# LIPPERT™ GREASE ZERK INSPECTION/CORRECTION PROCEDURE

Recall Number:	23E-046		
Product:	Grease Zerks		
Date:	July 10, 2023	Labor Rate:	Inspection - 0.3 hours per axle
			Repair - 0.3 hours per axle

Fig. 1

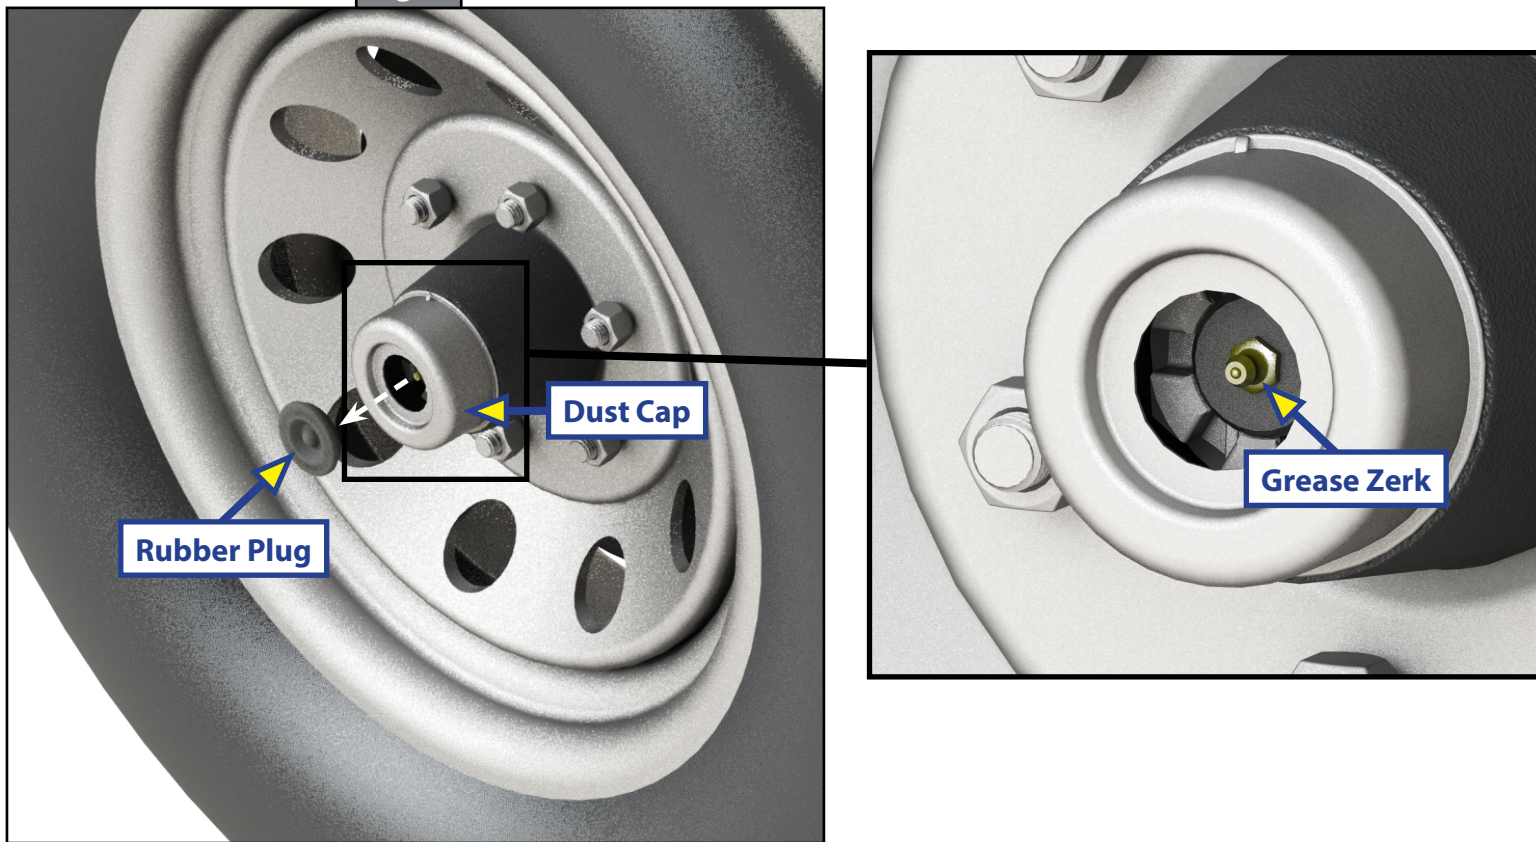
1. Use a flat screwdriver to remove the rubber plug from the dust cap (Fig. 1).
2. Inspect the grease zerk located behind the dust cap (Fig. 1).
  - A. Make sure the grease zerk is installed straight and no more than one thread is showing at the base of the zerk.
  - B. If more than one thread is showing or there is a gap in front, tighten the zerk to 90 to 100 in-lbs.
  - C. If the zerk is damaged, replace it.
3. Replace rubber plug on dust cap.
